COUNCIL ASSESSMENT REPORT – MODIFICATION APPLICATION

HUNTER AND CENTRAL COAST REGIONAL PLANNING PANEL

PANEL REFERENCE & DA NUMBER	PPSHCC-138
	DA/46209/2014/D
PROPOSAL	Modification of DA approved by Regional Planning Panel Variations to height and FSR over 10%
ADDRESS	Lots A & C, DP 355117; Lots 10 & 11, DP 591670; and Lots 1 - 4, DP 382784 27 - 37 Mann Street and 125 Georgiana Terrace, Gosford.
APPLICANT	Doug Sneddon Planning Pty Ltd
OWNER	Rola Property Group Pty Ltd
MOD LODGEMENT DATE	10 June 2022
ORIGINAL DA DETERMINATION DATE	15 December 2016
APPLICATION TYPE	Modification Application under Section 4.55(2)
REGIONALLY SIGNIFICANT CRITERIA	Clause 2 Schedule 6 of <i>State Environmental Planning Policy (Planning Systems) 2021</i> : General development over \$30M
CIV	\$ 45,316,738.50 (excluding GST)
CLAUSE 4.6 REQUESTS	Clause 5.25 (Height) and 5.26 (FSR) of State Environmental Planning Policy (Precincts—Regional) 2021
KEY SEPP/LEP	State Environmental Planning Policy (Precincts—Regional) 2021
TOTAL & UNIQUE SUBMISSIONS ISSUES KEY IN SUBMISSIONS	8

DRAFT CONDITIONS TO APPLICANT	No
SCHEDULED MEETING DATE	26 June 2023
PLAN VERSION	
PREPARED BY	Brett Brown, Director Ingham Planning, Plan

Figure 4 – Approved (left) and proposed (right) roof plan

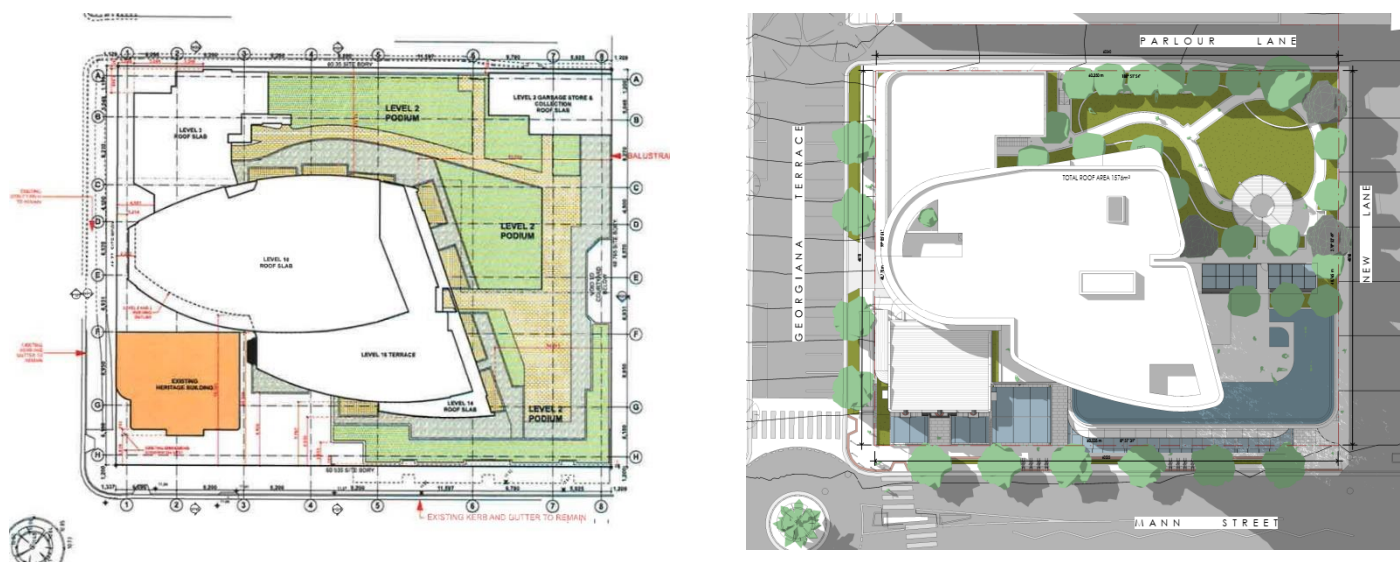
- Increased retail GFA from the approved 643.63sqm to 1,076sqm, a 432.37sqm increase;
- Increased parking from 209 to 217 spaces;
- changes to the building footprint and envelope including different apartment configurations and a total change to the external appearance of the development (see **Figures 3 and 4**);

- changes to the communal open space including the provision of a new external swimming pool (see **Figure 4**);
- expansion of the basement and a significant reduction in the amount of deep soil area;

The proposed modifications seek not only to increase the maximum height approved (by 3.87m) but to remove the stepping provided in the top part of the building. The lowest part of these stepped elements (in the SW corner of the building above Level 9) is increased in height by 14.73m. This loss of articulation increases the height, bulk and scale of the building and is contrary to the following height objectives:

Figure 9 Extract from DCP

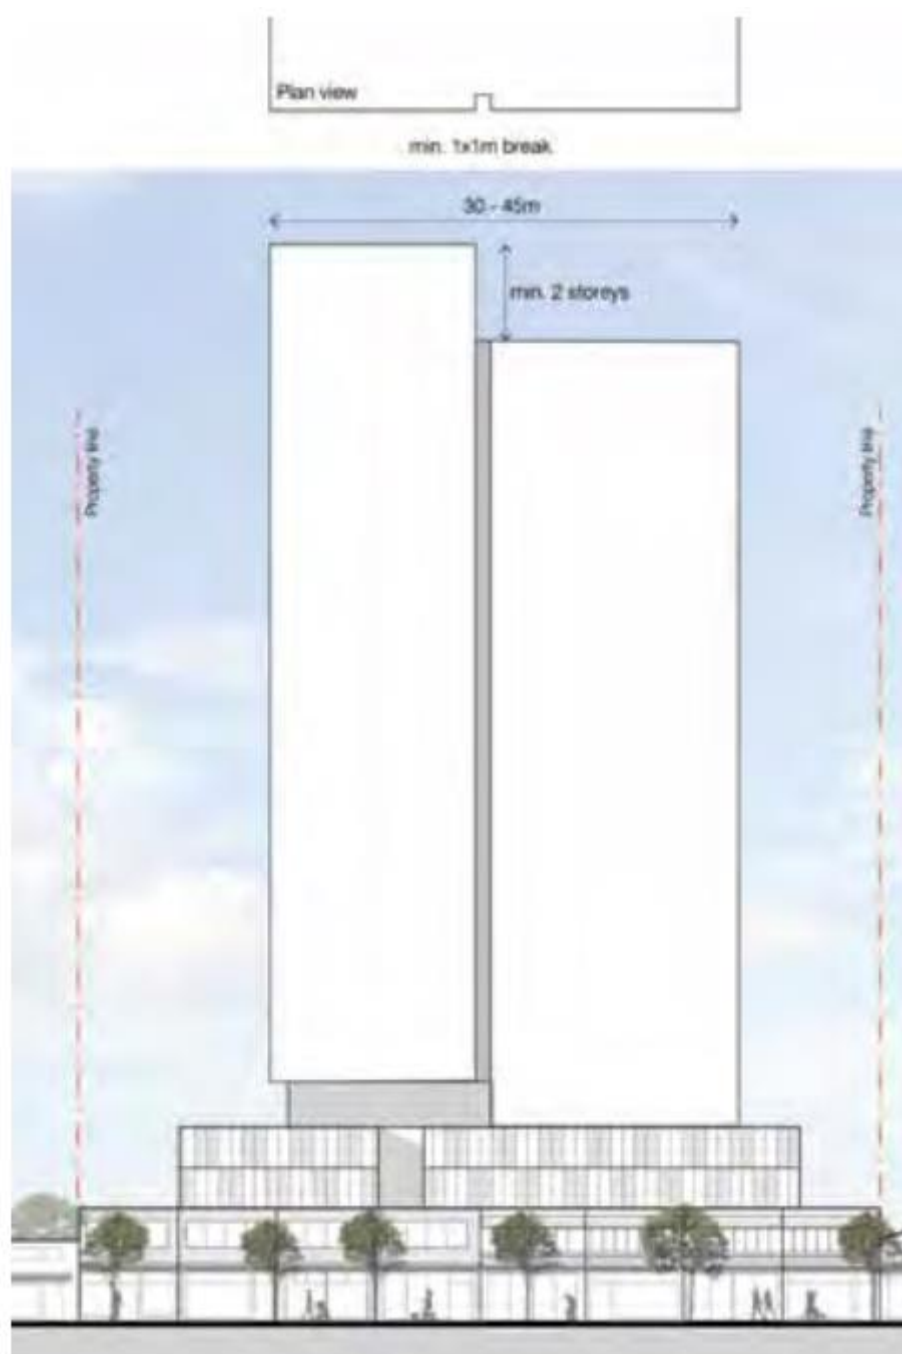
- a. expressed as two vertical forms*
- b. include a clear 'break' of minimum 1m width and 1m depth*
- c. include a stepped height difference of minimum two storeys*

The proposal excessively emphasises the horizontal elements and does not clearly express two vertical forms as required by the DCP and shown in **Figure 9** below. It also fails to provide a step in the top of the building as required. The approved building included some stepping albeit not as indicated in the DCP. Notwithstanding, the lack of any notable stepping emphasises the bulk and scale of the building and creates an unacceptable design outcome which is at odds with the objectives of the DCP for 'slender towers'.
